Supporting material for comment #46

Cl 119 SC 119.2.5.8 P 106 L 5 # 46
Slavick, Jeff Avago Technologies

Test Mode Datapath

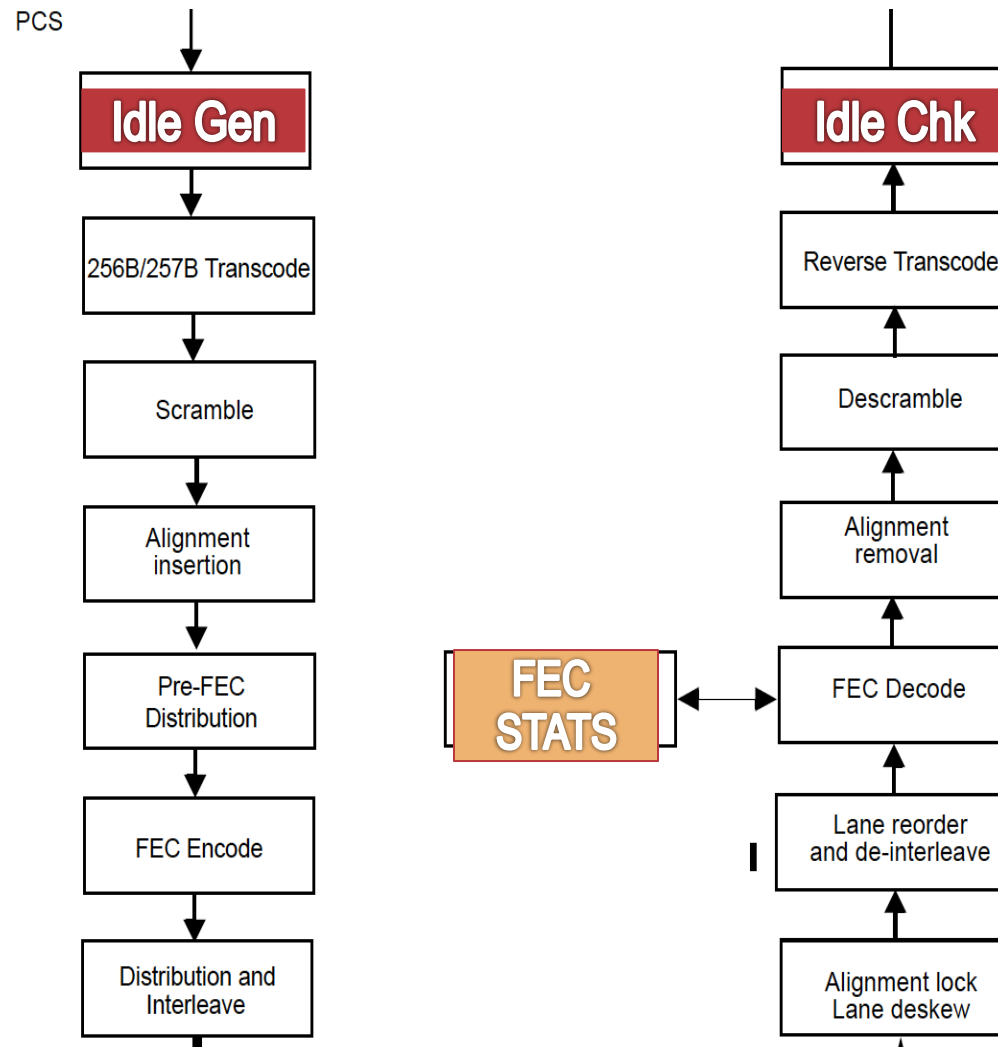
What is the point of the scrambled idle checker? FEC statistics provide superior granularity of error rate (10b checking instead of 66b) and you need the FEC engine to be running to provide valid data to the output of the descrambler. If you can't link up a full 400G PHY, then use a PMA test pattern. (Scrambled Idle Generation is needed to enable PCS to generate valid FEC data streams)

- **Counts the number of times a 66b block doesn't match IDLE block**
- **Idle Checker is after FEC engine**
 - So only time an invalid IDLE block would be seen is when an uncorrectable codeword is received.

- **Per Lane RS-symbol checkers**
 - Each PCS lane provides error count checked on a 10b granularity
- **Corrected codewords**
 - Count of number of corrected codewords, occurrences when 1-15 RS-symbols were detected having errors
- **Uncorrected codewords**
 - Count of number of uncorrected codewords, occurrences when ≥ 16 RS-symbols were detected having errors

- **All On –**
 - Every uncorrected codeword would induce 72¹ or 80 IDLE check violations since all sync headers are corrupted by error indication
- **Bypass Indication² –**
 - Uncorrectable error blocks will randomize the amount the errors in the data stream, so the number of IDLE check violations will not indicate an accurate representation of the errors received.
- **Detect Only³ –**
 - Mandated that indication is active, so any error on the link will cause 72 or 80 IDLE check violations to occur.

- **Remove the idle checker since its count isn't representative of the errors coming in on the received PCS lanes**
 - Gain no information on correctable codewords
 - Uncorrectable codewords cause large count increase such that idle check counter would likely be roughly 80x the uncorrectable codeword count
- **Rely on the FEC stats when testing with FEC input data**
 - per PCS lane error count with finer granularity (10b v 66b)
 - count of when ≥ 16 errors occurrences happened (when the idle checked would count errors)
- **Leave the Idle Gen in place to provide a defined method to generate a valid FEC data stream from the PCS**

Remove the scramble idle checker from clause 119.
